SAM HOUSTON STATE UNIVERSITY
Huntsville, Texas 77341

ADDENDUM 1 for 753-9-WHT012

PAINT AND TEXTURE PROJECT FOR BELVIN HALL 2009

Belvin - Buchanan
Ground Floor
(Plans not to scale)

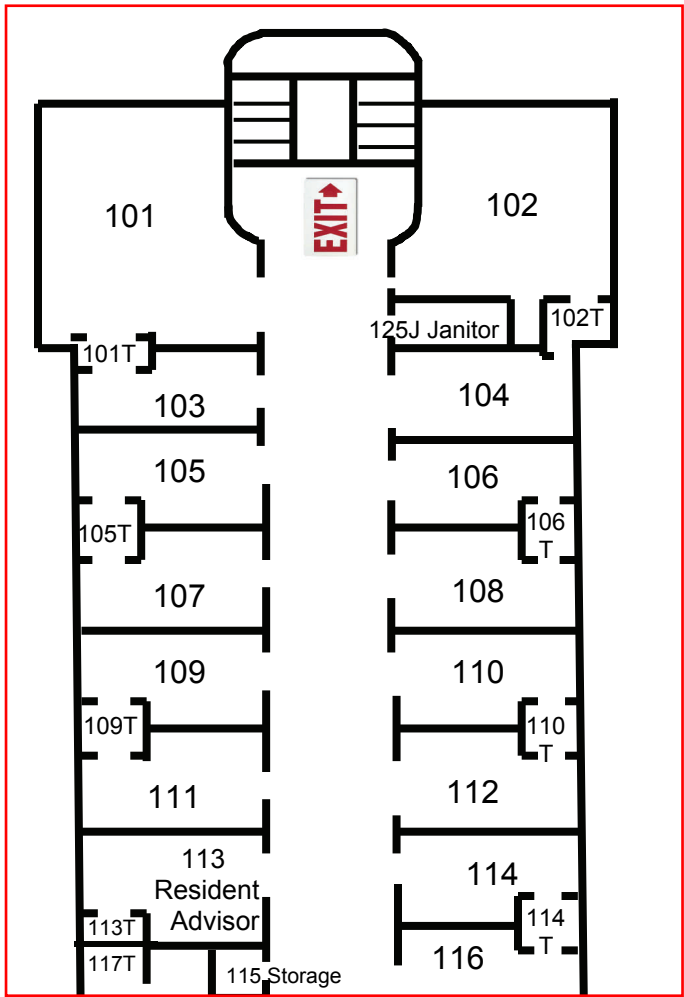
Contractor will not paint anything on
the Ground Floor.

Belvin - Buchanan
 First Floor
 (plans not to scale)

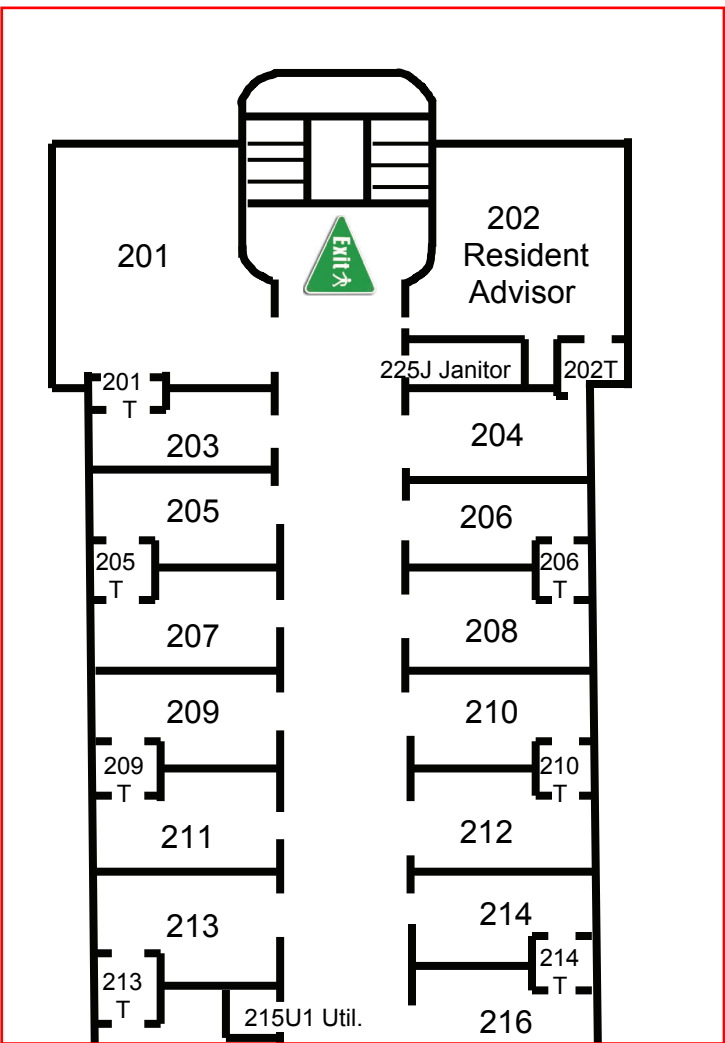
Area in red box is not to be painted. Contractor is responsible for painting from top of stairway at approximately room #116 back to elevator.

Belvin - Buchanan
Second Floor
(plans not to scale)

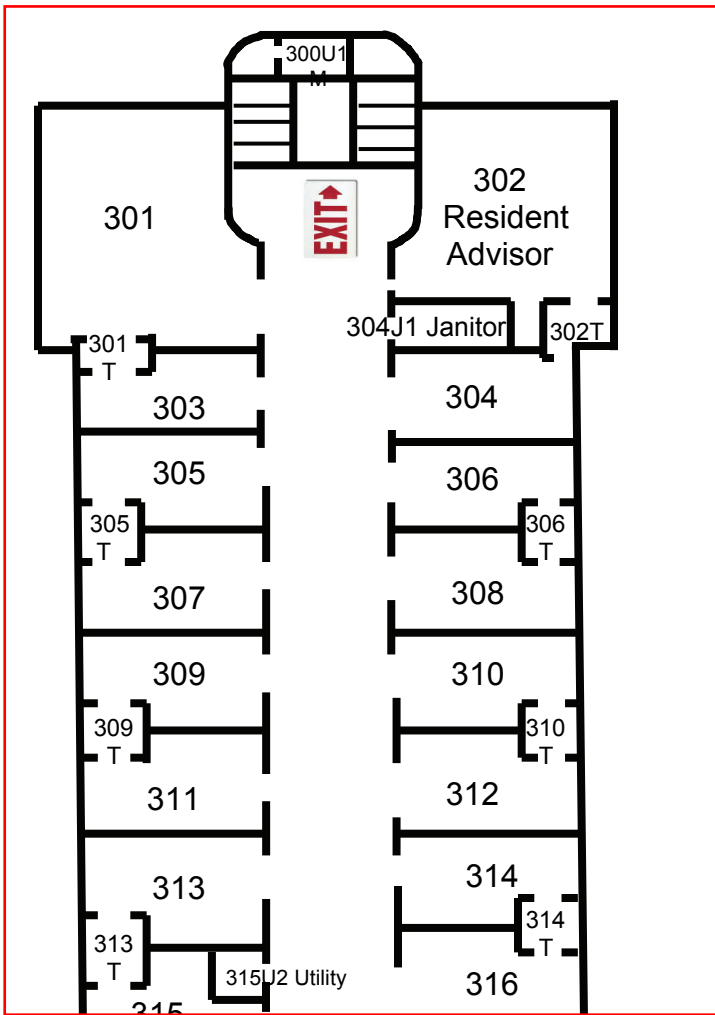
Area in red box is not to be painted. Contractor is responsible for painting from top of stairway at approximately room #216 back to elevator.
